**APPLICATION AND
PRELIMINARY PLAT CHECKLIST**

NAME OF PROPOSED SUBDIVISION The Shores Phase Four

PRELIMINARY PLAT

Agenda Item: **P&Z 93-3-PP** - Discuss and Consider Approval of a Preliminary Plat for Phase 4, Shores, a 26 lot Subdivision South of Ridge Road West

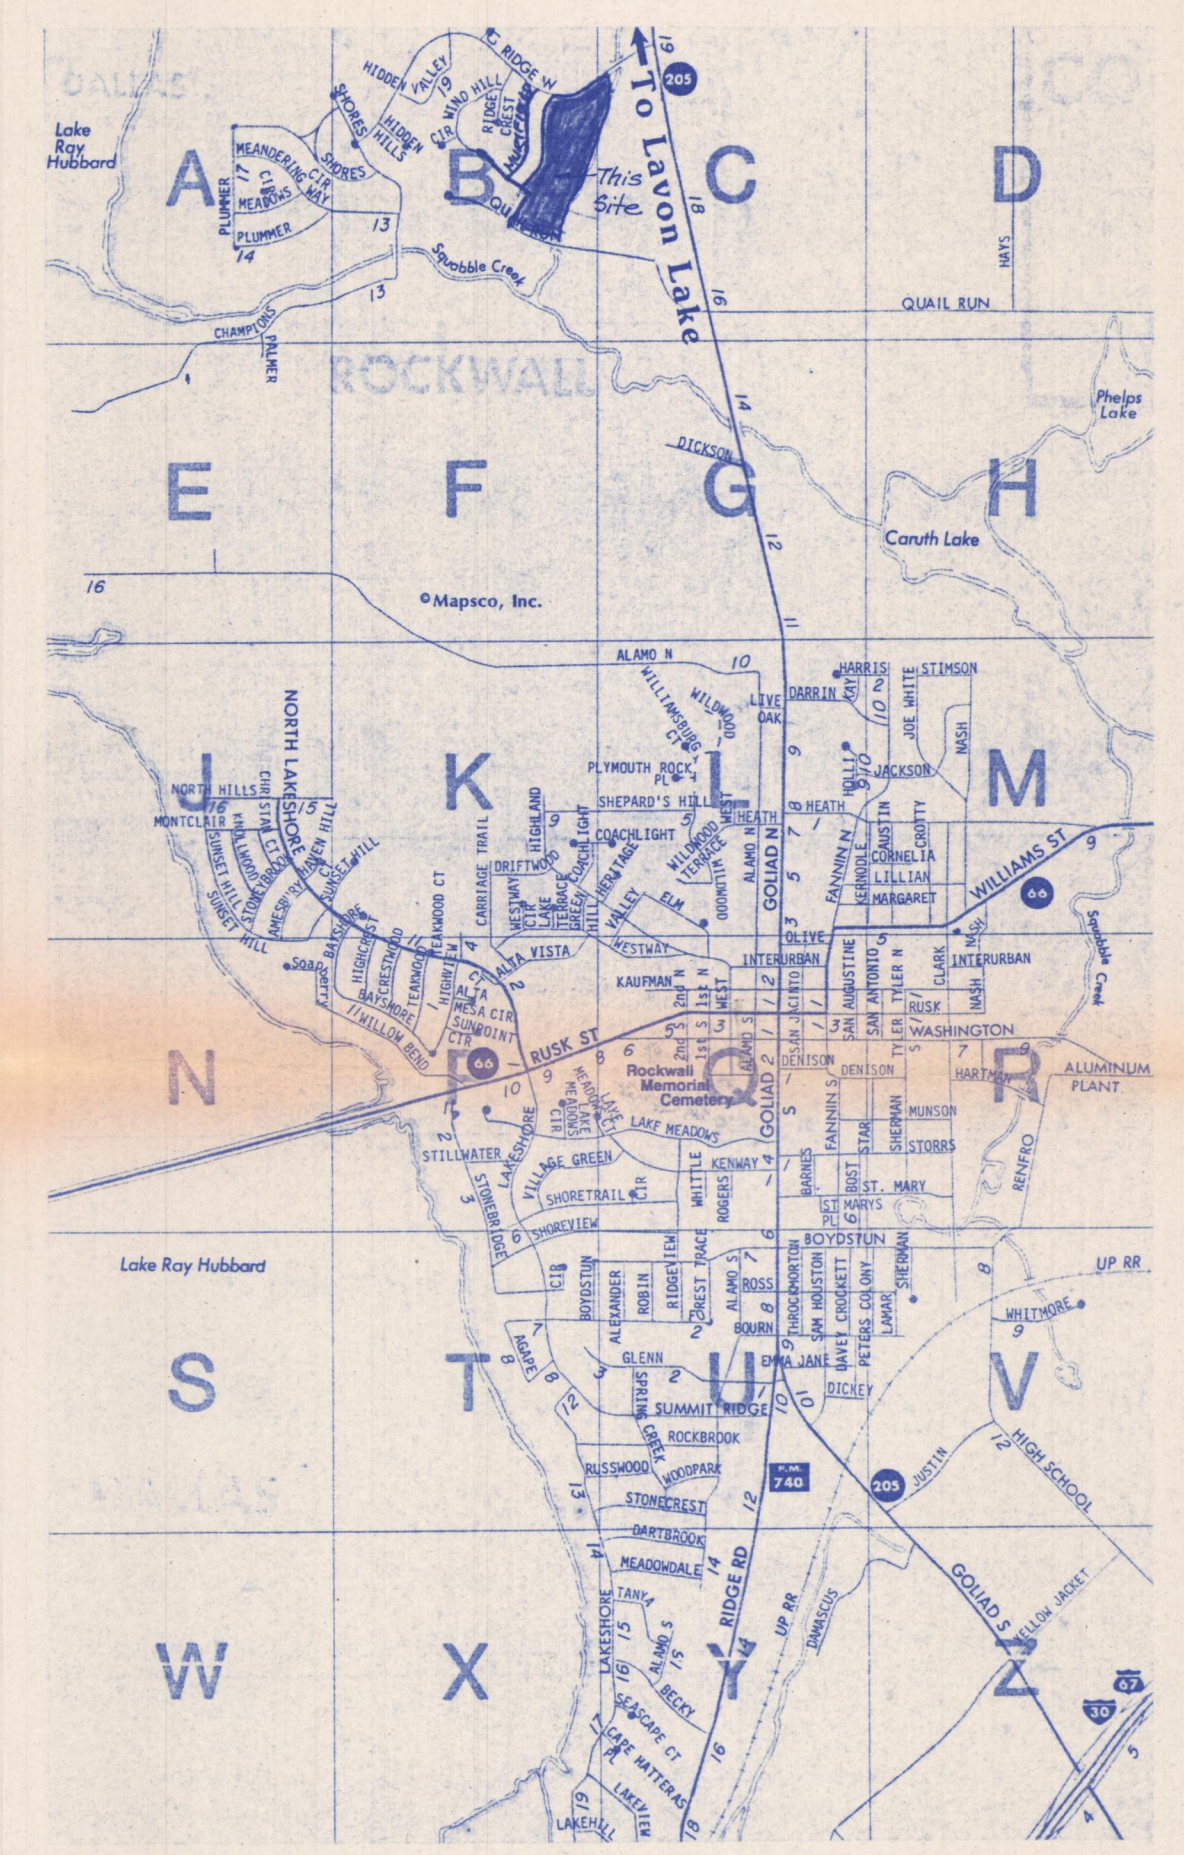
Handwritten notes and sketches in the upper right quadrant of the map.

PRELIMINARY PLAT

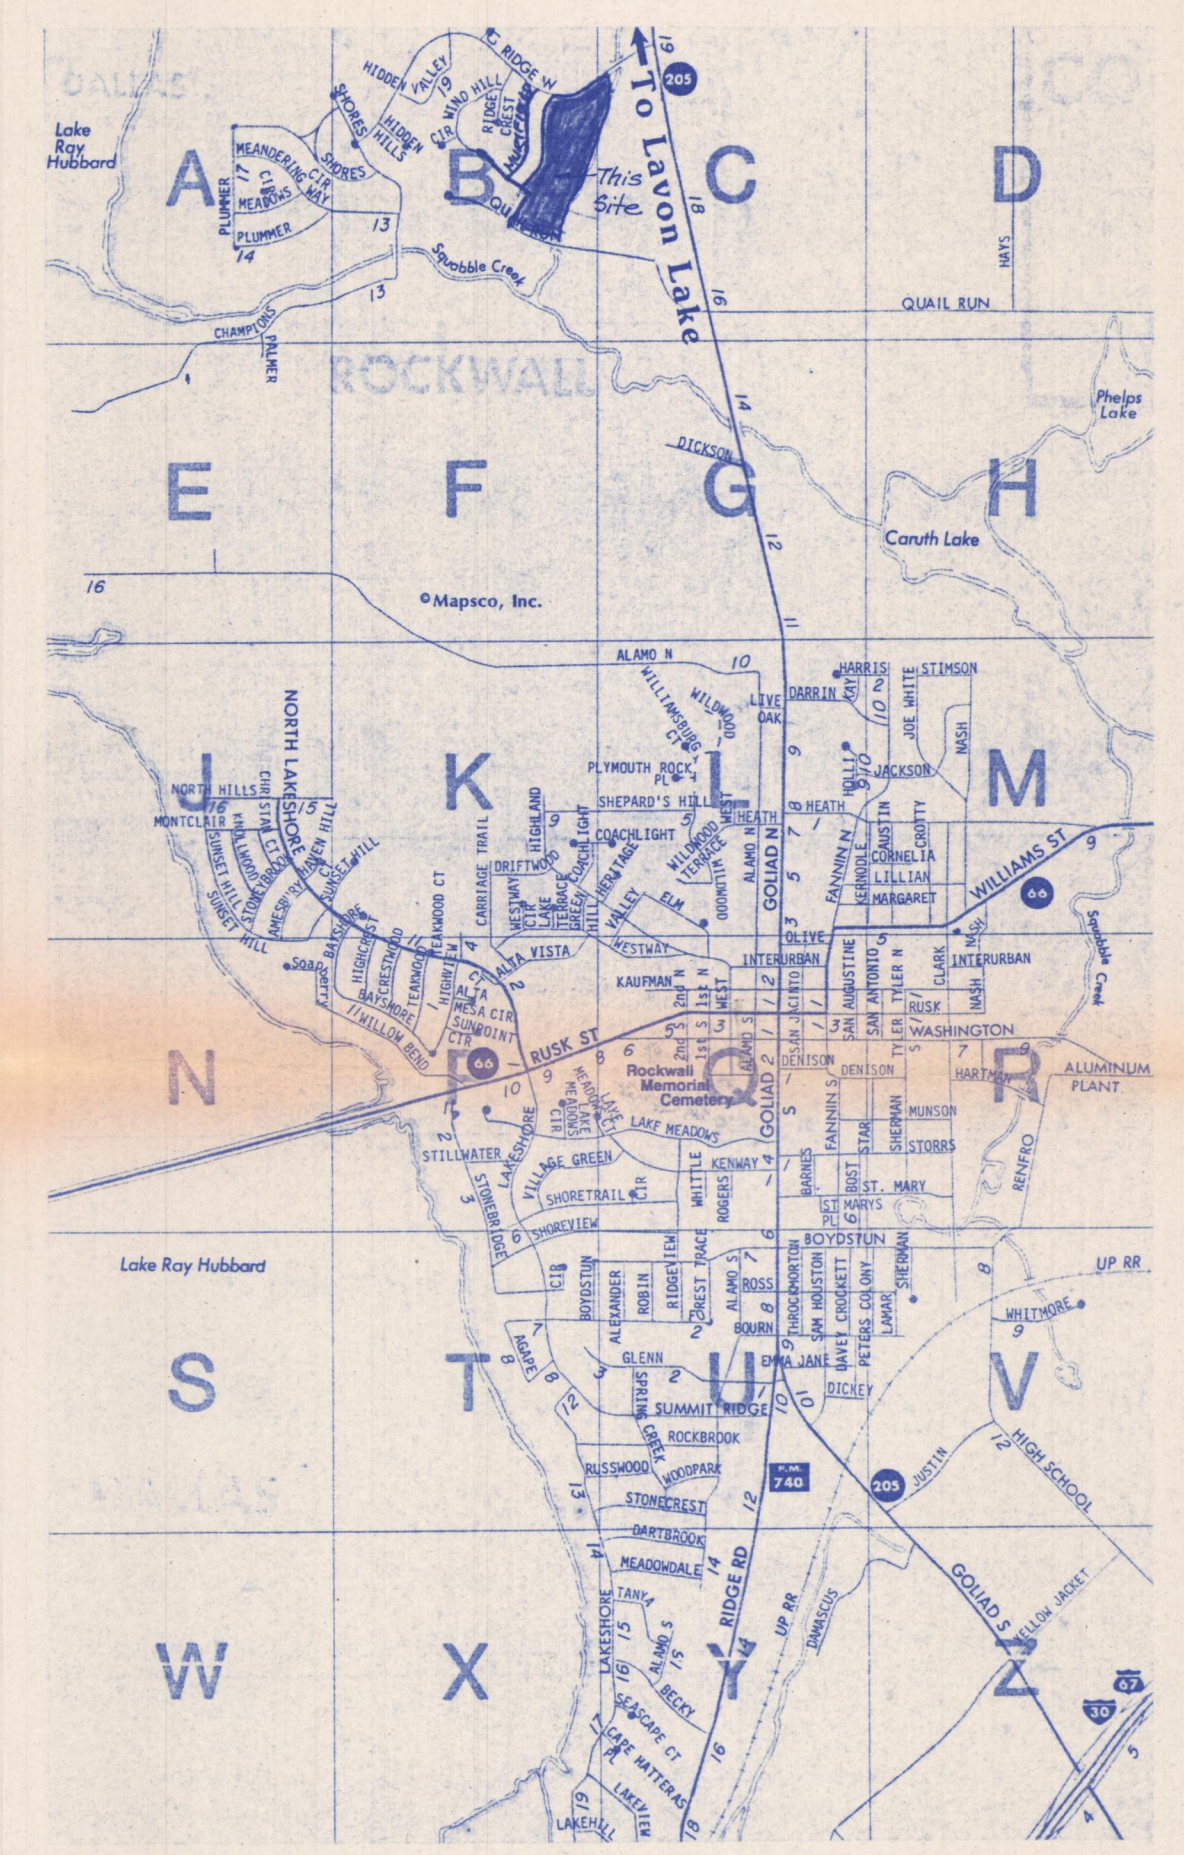
1. Storm Drainage - As mentioned the site is adjacent to a drainway to the east. We do not know at this time if any improvements will be necessary to the drainway and won't until an analysis of the drainway is completed. In addition to possible improvements there is the question of what to do with the drainway and its future maintenance. The PD ordinance provided that the drainway would be maintained by the property owner and would be improved at the time the multifamily tract to the east is developed. This, however, was done when the same developer owned both tracts. The multifamily parcel is now under separate ownership.

The developer does not want to maintain the property permanently and the only options are to a) dedicate the property as open space to a homeowner's association, b) incorporate the drainage channel into the individual lots and establish a drainage easement, c) dedicate the property as drainway right of way to the City, or d) dedicate the property to the City for park property. We do not know at this point what we believe to be the best option for the City. The decision will depend somewhat on the determination of what if any channel improvements might be necessary.

2. Dedication and escrow for Quail Run Road - this plat backs up to Quail Run Road and the developer must dedicate the necessary right of way for the future widening of Quail Run. they must also escrow the cost of widening that portion of Quail Run, just as they did on the previous phase in this area.

3. Waiver of Alleys - They have asked for waivers to the alley requirements along the drainway and Quail Run Road, which are consistent with previous waiver requests. Three of the lots are proposed to face Ridge Road West and have access off of a half cul-de-sac. We have a problem with this design because there is no room for onstreet visitor parking. Harold Evans has developed two alternatives which are in the packet, one which includes an alley and one which lengthens the cul-de-sac. Until the drainage study is completed we do not know which alternative is the best as it relates to the drainway in the rear. The longer cul-de-sac would offer more room for on street visitor parking.

Generally, we would recommend that the preliminary plat be approved subject to completion of a flood study and resolution of the above identified issues prior to submission of the final plat.

1. Cul-de-sac alternatives

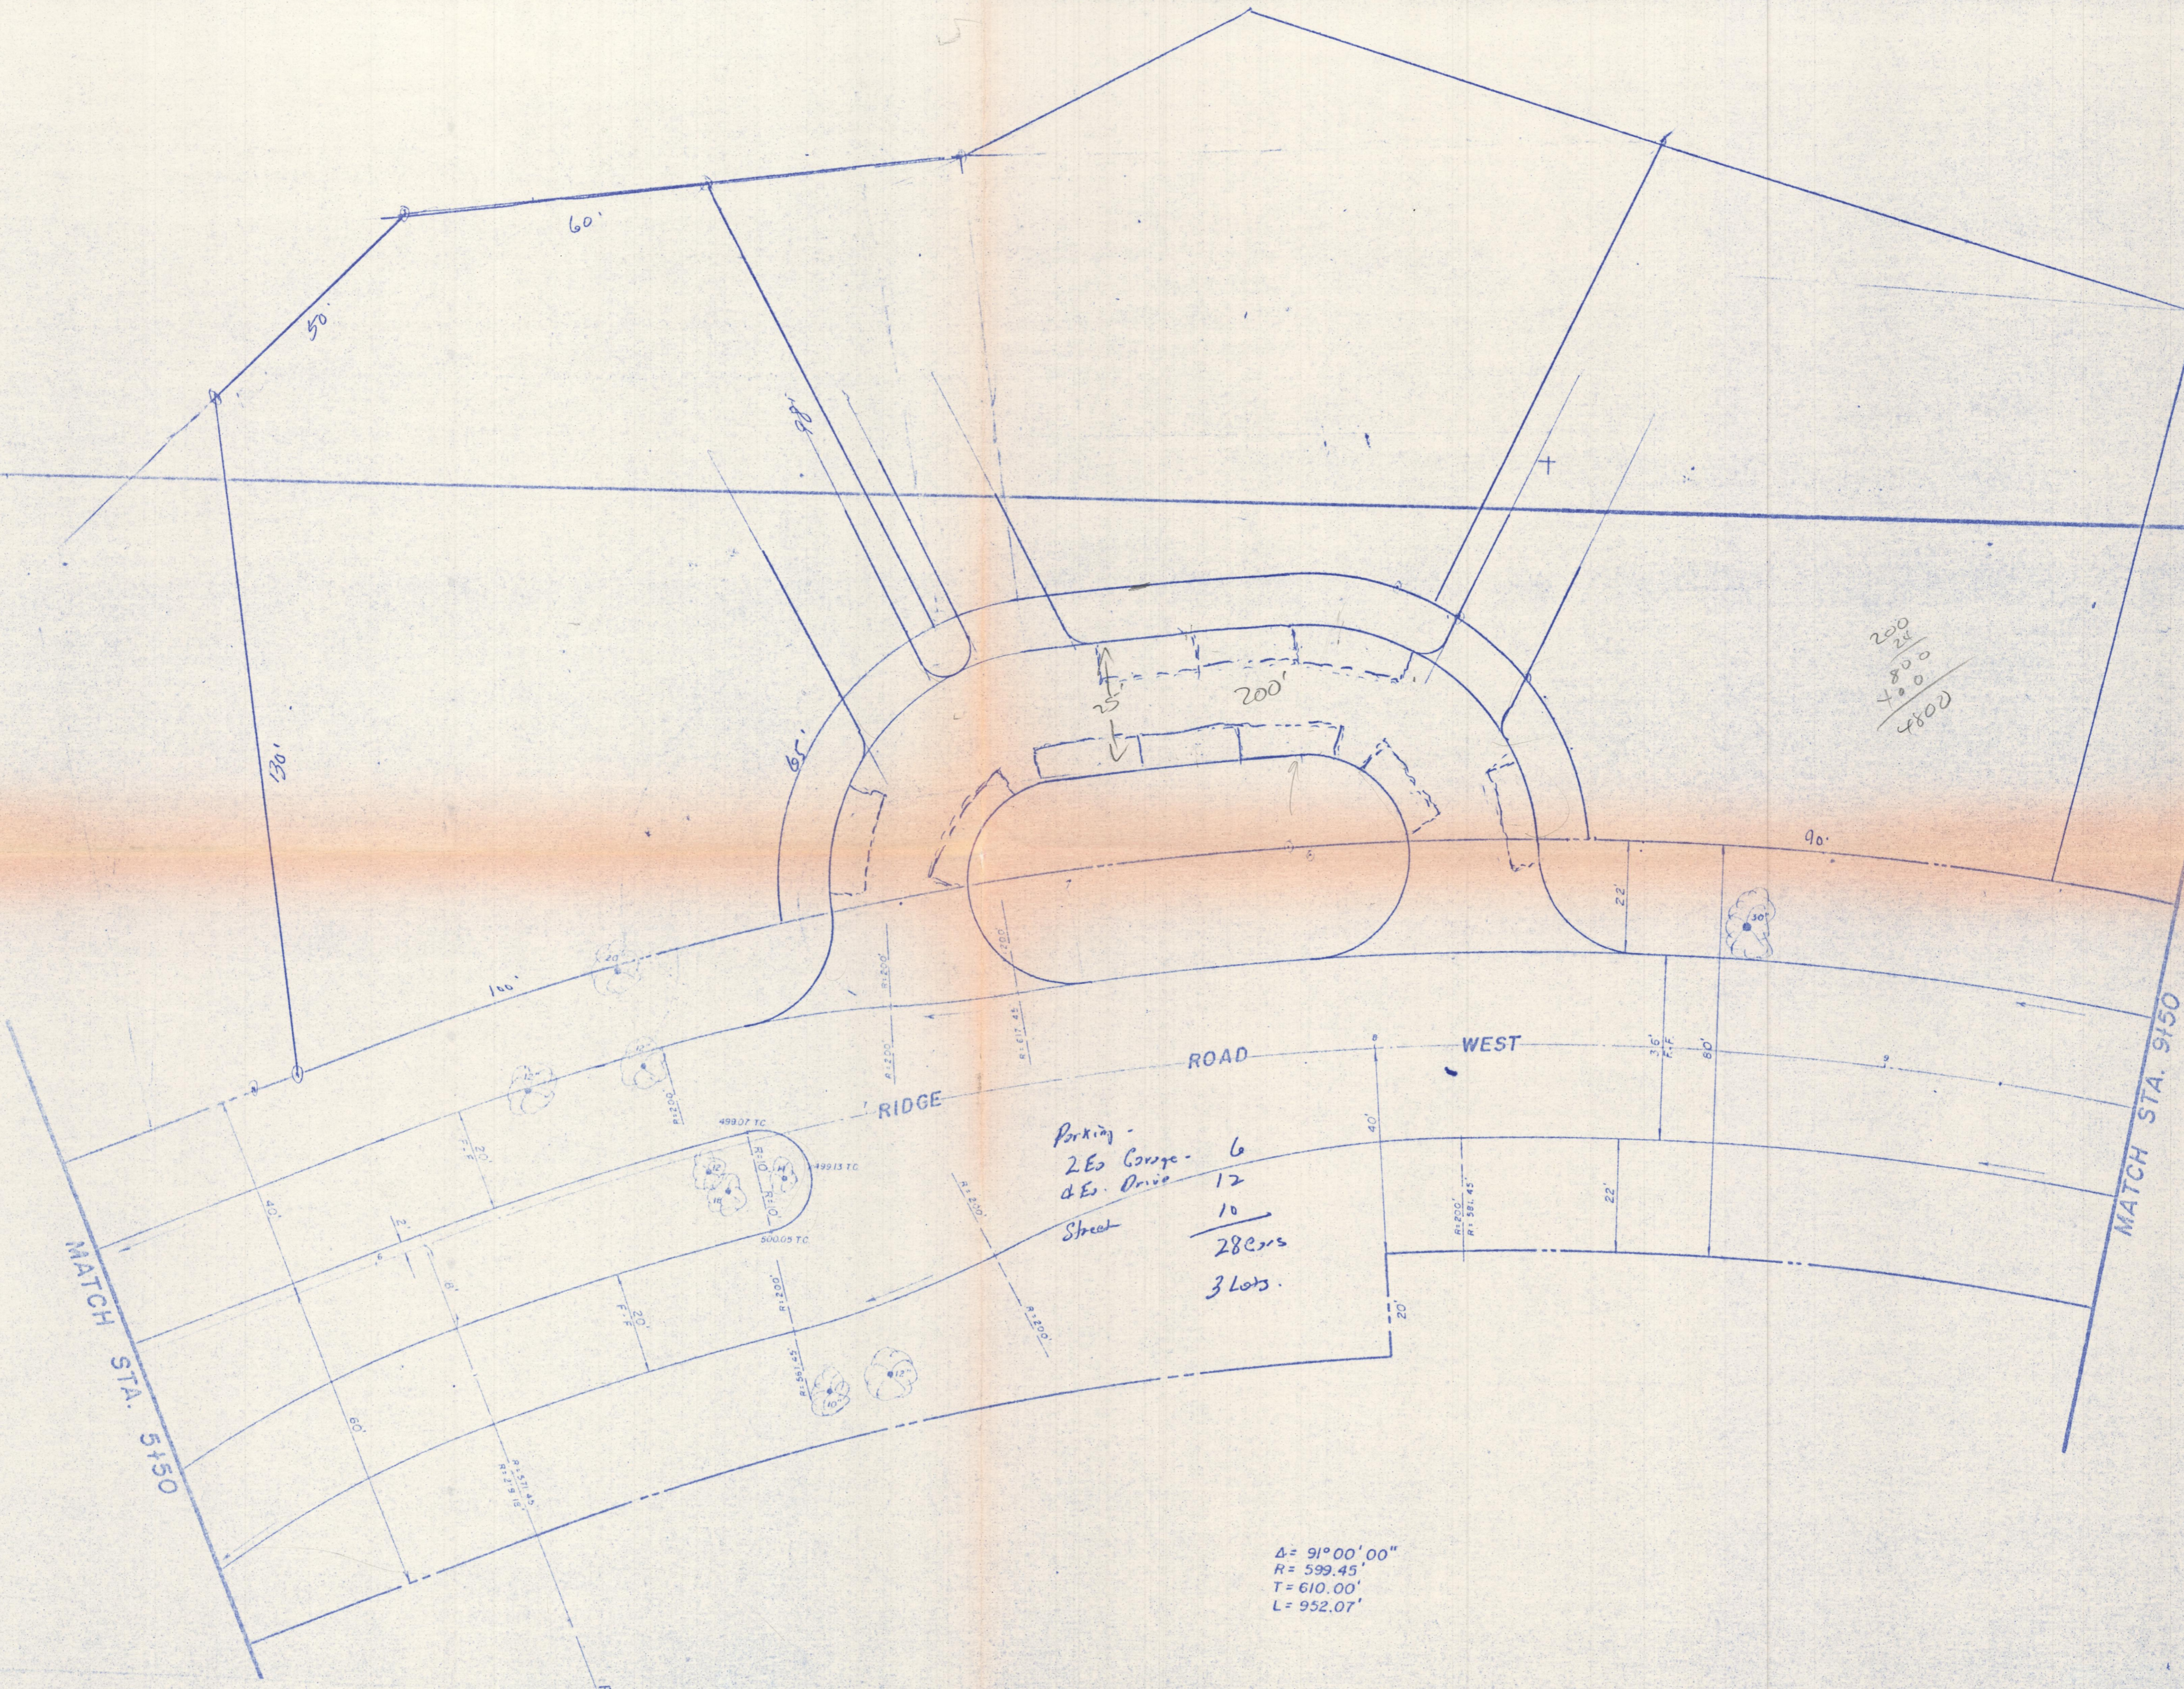
The Commission considered this item on Thursday night and have recommended to approve the preliminary plat subject to the completion of a drainage study, final resolution of the dedication and improvement of the drainway, the final design for lots 51-53, the dedication of right of way and escrow for Quail Run Road and the restriction that lots 51-53 not be permitted to have front entry garages.
